PLANNING APPLICATION REF. 18/00812/FULL

**DESCRIPTION OF DEVELOPMENT:
PART RETROSPECTIVE RAISED DECKING AND ASSOCIATED STEPS**

FERN COTTAGE KIRKTON OF AUCHTERHOUSE DUNDEE DD3 0QS

REPRESENTATIONS

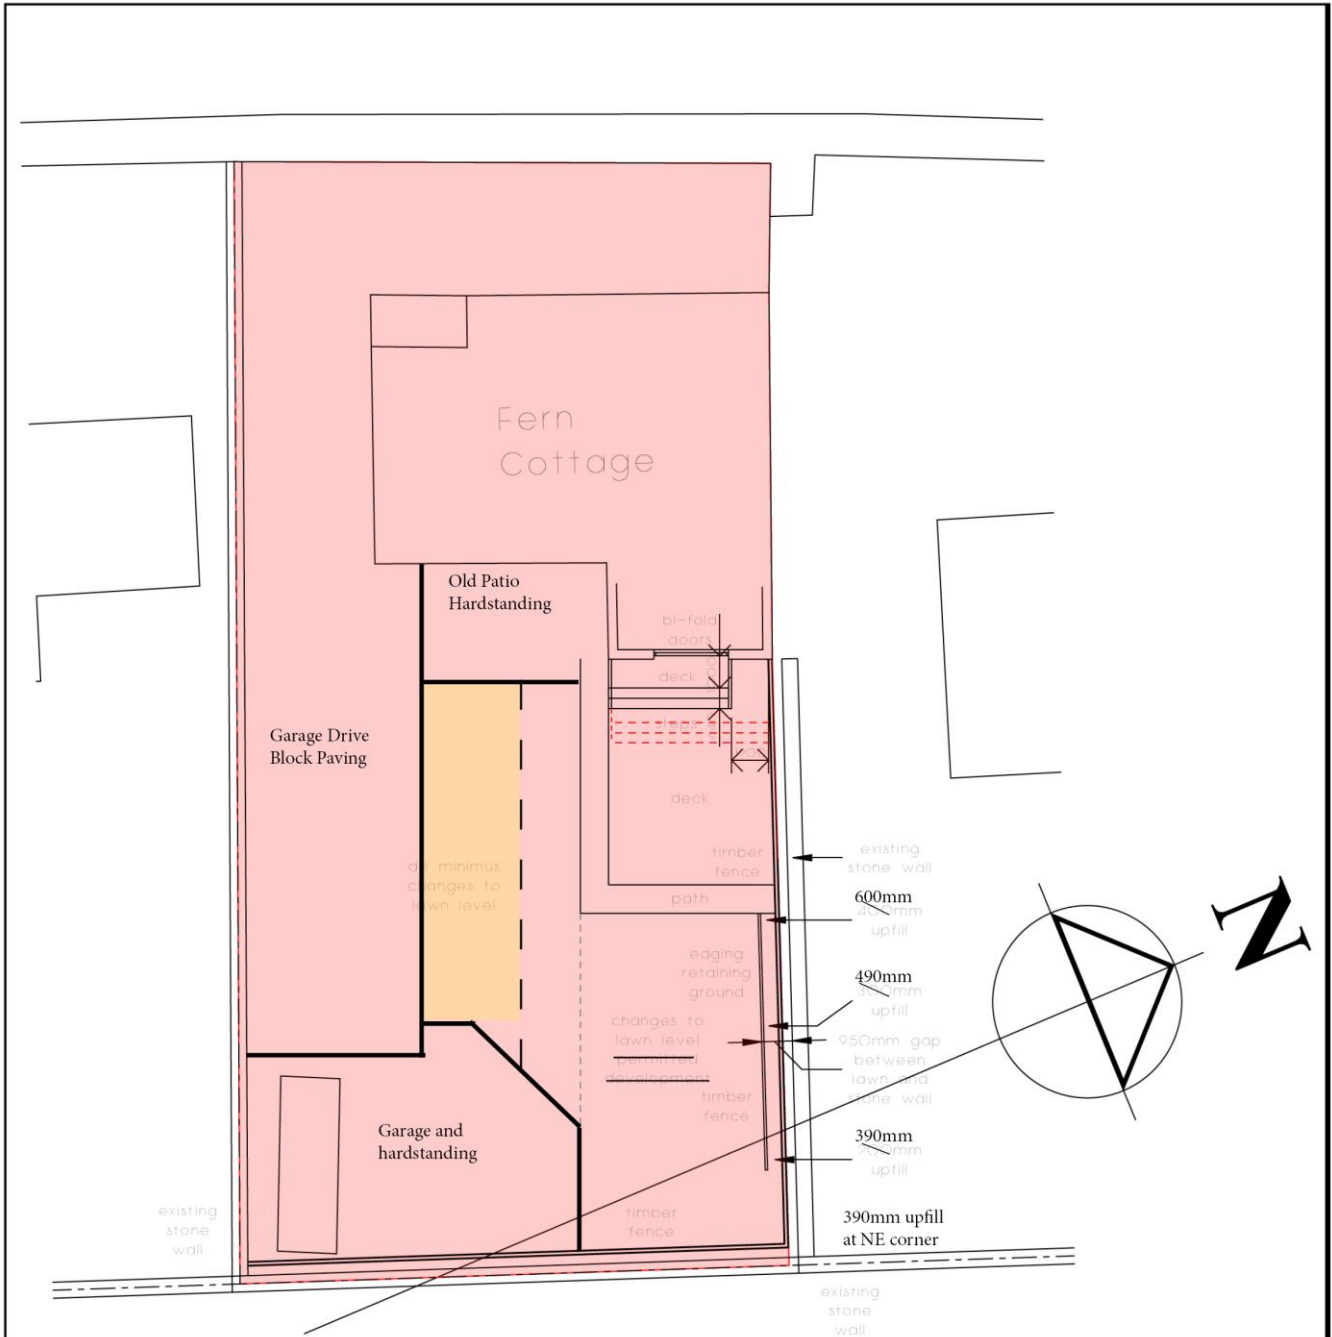
On examining these photos, and in particular the 2 undernoted ones, you will find that the levels/heights of the deck and raised soil levels, which are derived from using those levels stated in the recently submitted section drawing, appear to be conservative in arriving at their respective heights within **Document 1**, when compared to the actual deck and raised soil levels shown in the photos.

At the east edge of the deck when you examine these photos you will note that the deck level is 8 planks (at 150mm each=1.200M) down from the top of the fence and that the raised soil level, once projected through to the fence, is approx. at the underside of the 9th plank at 1.350M down from the top of the fence.

Given that the fence, at this location, is 1.950M high from original ground level (as per calculations contained in **Document 1**) results in both the deck being close to 750mm high and the raised soil level being close to 600mm high when compared to original ground levels.

As stated previously, both these heights are considerably higher than those quoted, by yourselves, in previous documents viz.480mm and 410mm respectively.

I would point out that even using the inaccurate levels within the appellants' Section drawing still gives a height of 1.880M for the as-erected fence (10.68 minus 150 minus 8.65 = 1.880M) and a deck height of 660mm (1.88 minus 1.22 = 660mm). This lower height of 660mm still exceeds the permitted height of 500mm for a deck.

Document 1 highlights the inaccuracies in the measurements, therefore the actual position, as currently detailed on the drawing, when corrected, would be more detrimental by 70mm.
